Manh Choh ore extraction site DNR/DEC permit comment
(manh.choh.comments@alaska.gov)

Draft Waste Management Permit 2023DB0001
And
Draft Reclamation Plan Approval (F20232626RPA)

Figure 1: From Bemis, S.P., Weldon, R.J. and Carver, G.A., 2015. USGS Earthquake catalog: 2000 to 2013 to 30 kms depth and > M2. Red square general extraction area.

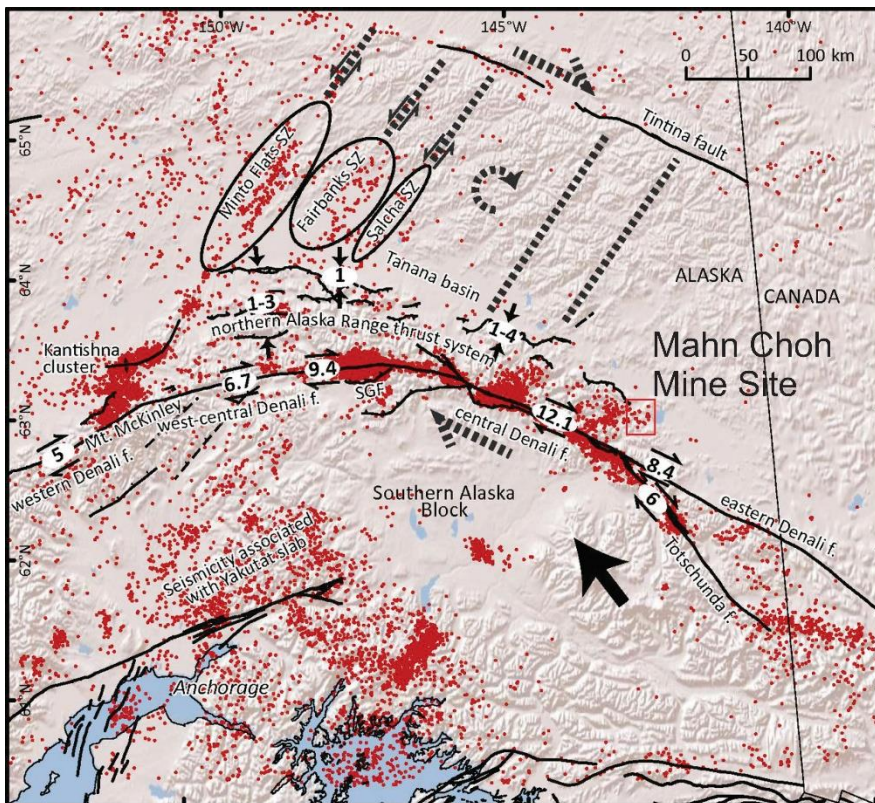
In my review I could find no mention of earthquake/seismic hazards-considerations in any of Manh Choh **extraction** site permit/plan documents. The Manh Choh **extraction** site is ~40 kms from the Denali Fault, one of the most seismically active faults in the world which ruptured in 2002 with M7.9. (Eberhart-Phillips et al., 2003). The devastating Turkey quake for comparison was a M7.8.

The active Cathedral Rapids fault (Carver et al., 2010; Koehler et al., 2012; Bemis et al., 2012; 2015), a low-angle thrust, is ~15 kms to the north west of the Manh Choh extraction site and part of the Northern Alaska Range Fold and Thrust Belt seismic region which can generate M6 earthquake events (Doser et al., 2023). Doser et al. (2023) stated

Not only is the Manh Choh extraction site located between two active major structures, but the region itself is dissected by faults (Fig. 1) (Avalon et al., 2013; Illig, 2015). Plotted earthquakes from the USGS earthquake catalog from 2000 to 2013 to 30 kms depth and > M2 demonstrate the mine site itself can experience seismic events (Fig. 2). How will the covering on the north pit respond to seismic events? Will the planned lake in the south pit drain during a seismic event?

8) Kinross-Contango Ore-Peak Gold LLC should be required to do a seismic hazard assessment for the Manh Choh ore extraction site and how it may or may not affect their waste management/reclamation plans before being awarded a DNR/DEC permit/accepted plan. The extraction site is located between active the Cathedral Rapids and Denali faults and the extraction-waste storage site has many documented faults-some likely seismically active based on the large number of earthquake epicenter located on the extraction property.
